Access Compliance Report

Public Rights-of-Way

Intersection ID: 45862	Main Street: JAMISON_LN	Cross Street: HENDERSON_OAKS_DR	Location: NE
ADA ID: BFDA6DB8EC0	Ramp Type: PerpDiag	Initial Pass/Fail: Fail	Overall Compliance: No
Severity Score: 33.75			
Codes/Mitigation Info/Possible Solution		Field Measurements/Component Compliance

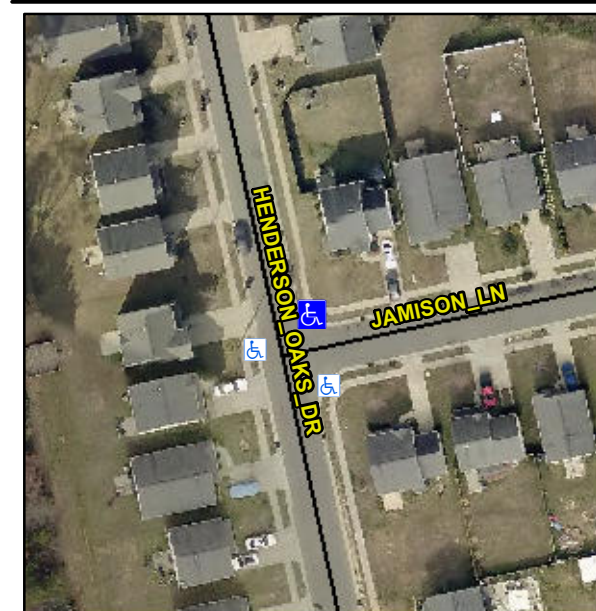
Not Found, R304.5.1, R304.2.2

Compliance	Description	Data	Compliance	Description	Data
N/A	Ramp Length (in)	47.0	No	Ramp Slope (%)	12.8
No	Ramp Width (in)	36.0	Yes	Ramp XSlope (%)	1.6
N/A	Flare Type LT	N/A	N/A	Flare Type RT	N/A
N/A	Flare Slope LT (%)	N/A	N/A	Flare Slope RT (%)	N/A
N/A	Flare Traversable LT?	N/A	N/A	Flare Traversable RT?	N/A
N/A	Landing Length (in)	N/A	N/A	DWS Provided?	N/A
N/A	Landing Width (in)	N/A	N/A	DWS Contrast?	N/A
N/A	Landing Slope (%)	N/A	N/A	DWS Length (in)	N/A
N/A	Landing X Slope (%)	N/A	N/A	DWS Full Width?	N/A
N/A	Landing Curb? (Y/N)	N/A	N/A	DWS Offset (in)	N/A
N/A	Shared Landing?	N/A			
N/A	Gutter Ponding?	N/A	N/A	Gutter Slope (%)	N/A
N/A	Gutter Lip Ht (in)	N/A	N/A	Gutter X Slope (%)	N/A
N/A	Painted X Walk1?	No	N/A	Painted X Walk2?	No
	X Walk 1 Direction	To W		X Walk 2 Direction	To S
N/A	X Walk 1 Width (in)	N/A	N/A	X Walk 2 Width (in)	N/A
	X Walk 1 Slope (%)	1.9		X Walk 2 Slope (%)	4.4
	X Walk 1 X Slope (%)	1.6		X Walk 2 X Slope (%)	1.4

Remove & Replace Curb Ramp With Two New Directional Ramps or Equivalent.
